**SAN ANTONIO WATER SYSTEM
Traders Village 36-inch Oversize
(16-inch Required) Project
SAWS Job # 09-1046
SAWS Solicitation No. B-10-022-CM
ADDENDUM NO. 1**

March 4, 2010

Traders Village
 36-Inch Oversized (16-Inch Required) Water Main
 SAWS Job No. 09-1046
 Solicitation No. B-10-022-CM

PLAT NO. **090218**
 JOB NO. **7325-05**
 DATE **FEBRUARY 2010**
 DESIGNER **KS**
 CHECKED **JW** DRAWN **JV**
 SHEET **CW3.0**

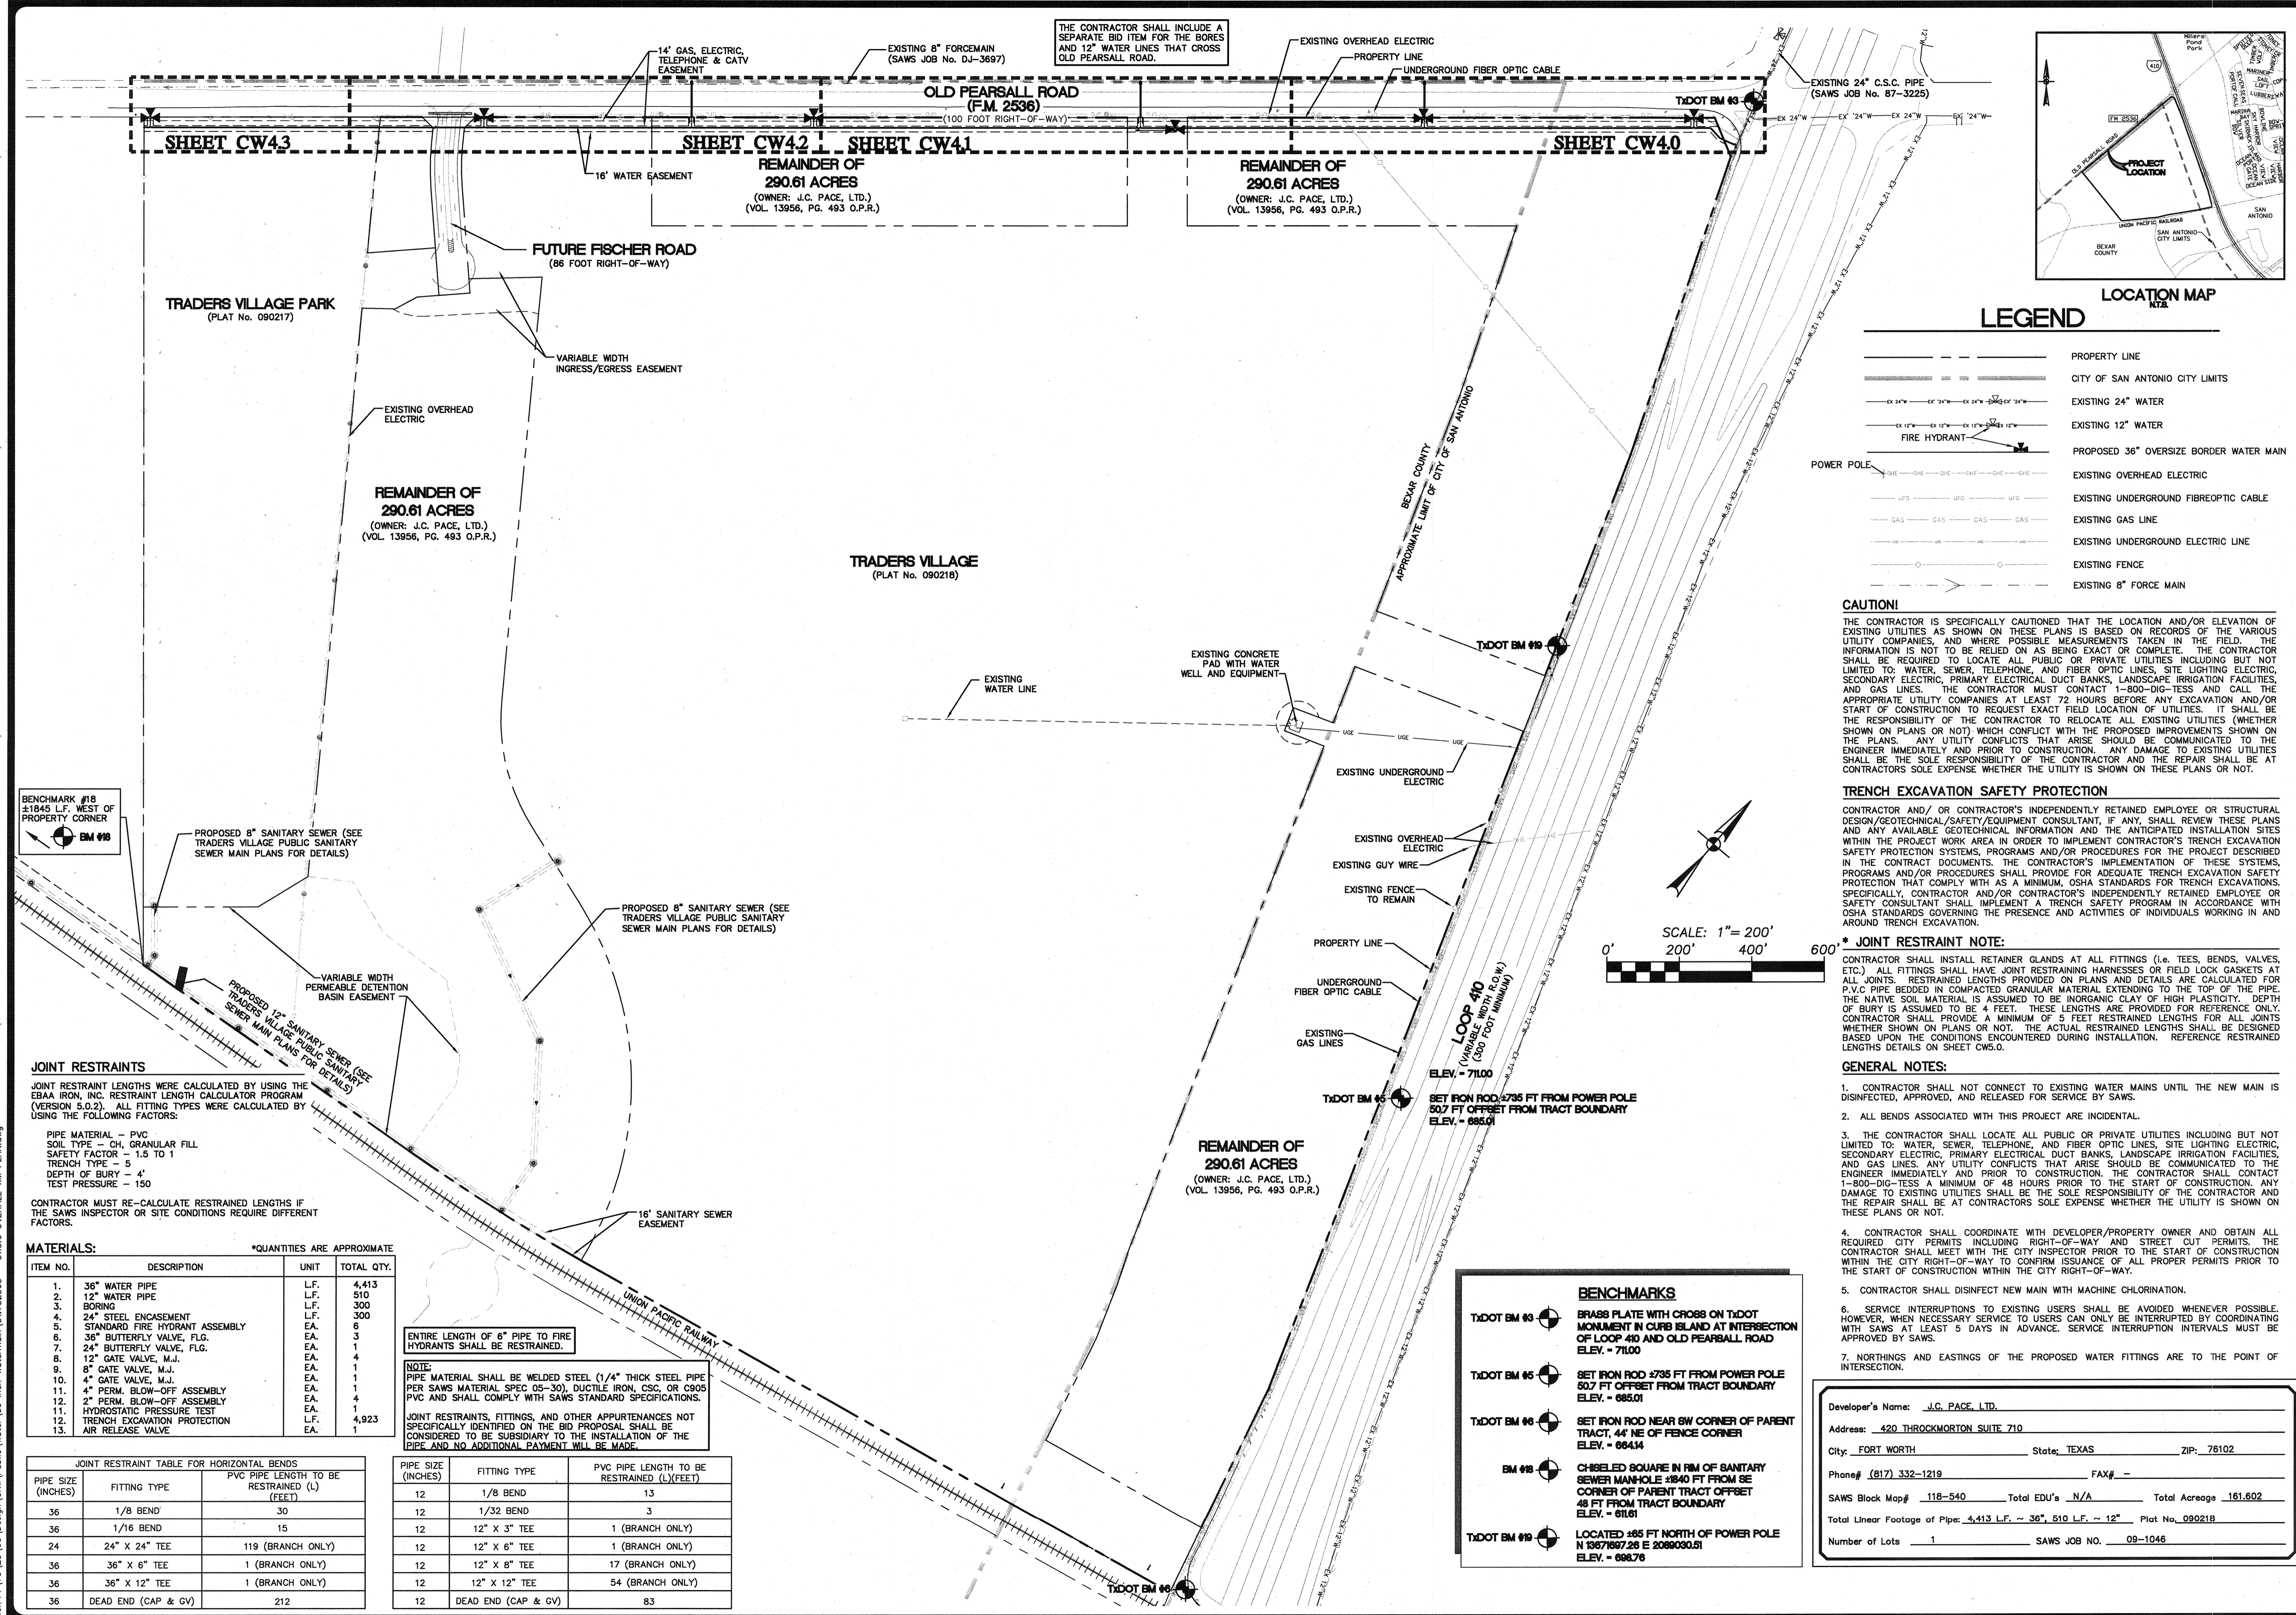
QUESTION: "There is a 12"X8" tee and a 12"X4" tee with no gate valves attached to the branch and no plug on the end. There should be."

RESPONSE: Gate valves and plugs were omitted and have been attached to the revised drawing and updated on the revised bid proposal.

PLAT NO. 090218
JOB NO. 7325-05
DATE FEBRUARY 2010
DESIGNER KS
CHECKED JW DRAWN JW
SHEET CW4.0

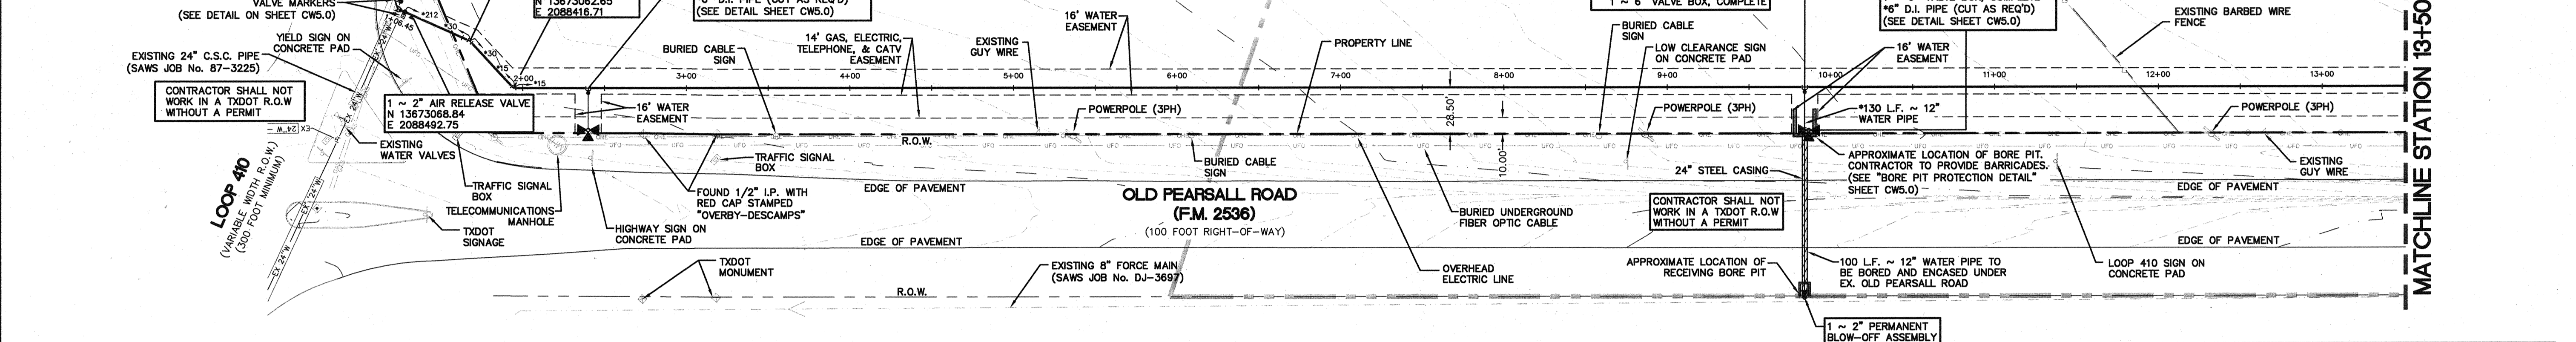
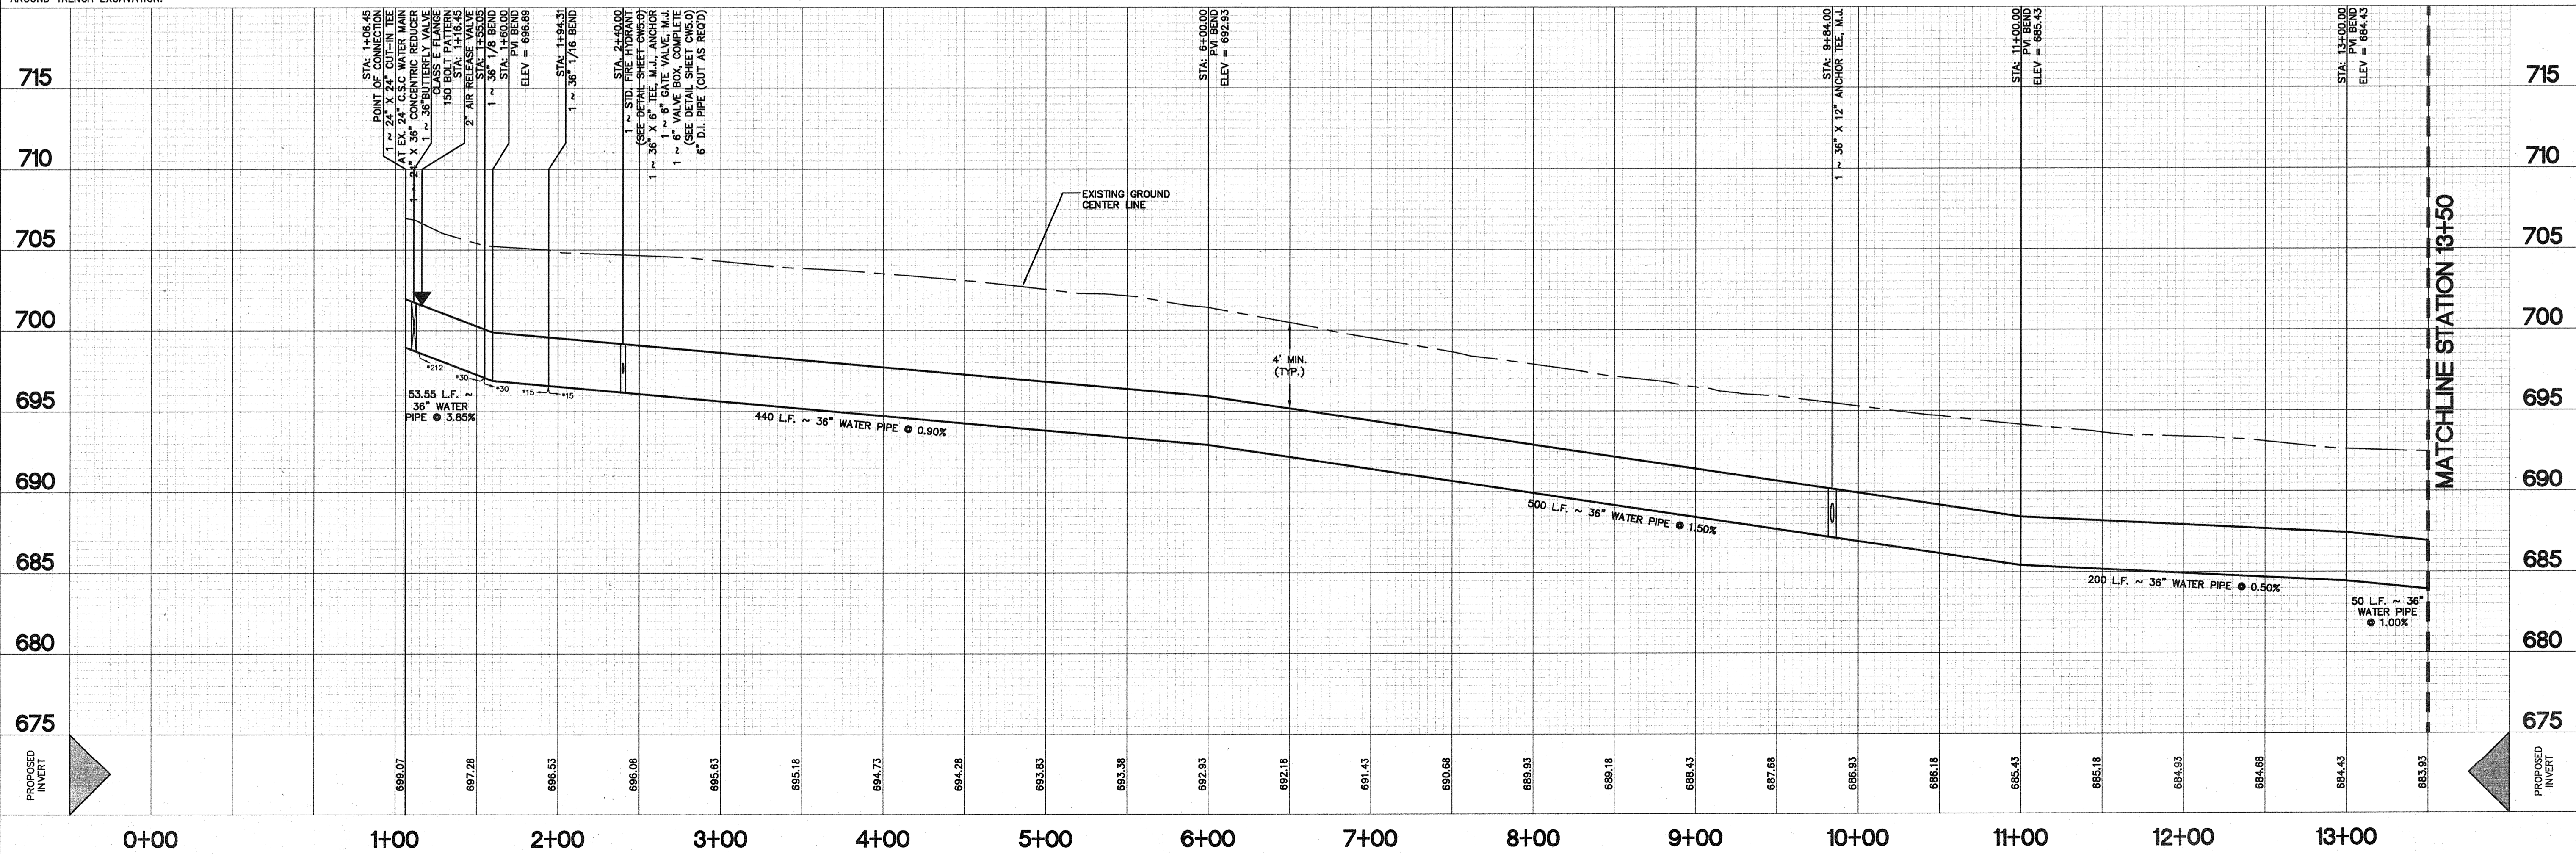
QUESTION: "On the first page on the plans, CW4, the engineer (?) has a bull head tee beginning the project. They are not available in that size, 24"x 36". There needs to be a 24" Flg tee with a Flg X MJ reducer 36" x 24" to begin the line."

QUESTION: "Should the reducer at the beginning of the project be eccentric?"

RESPONSE: The Tie-in to the 24" water main has been revised. Please see the revised plan sheet with this addendum.

RESPONSE: The 24" x 36" reducer should be concentric. Please see the revised plan sheet with this addendum.

QUESTION: "The contractor also mentioned that we may want to clarify that the butterfly valve at the 24" tie-in point must be flanged due to the existing CSC pipe type."

QUESTION: "36" Butterfly Valves. According to the contractor, the SAWS detail shows a flanged valve, but the bid item is a "M.J.". Are both types accepted by SAWS?"

RESPONSE: The 24" and 36" Butterfly valves should be flanged. Revised Bid Proposal is attached.

RESPONSE: The 36" and 24" Butterfly Valves should be flanged. See SAWS Specification 830. Bid Proposal has been revised.
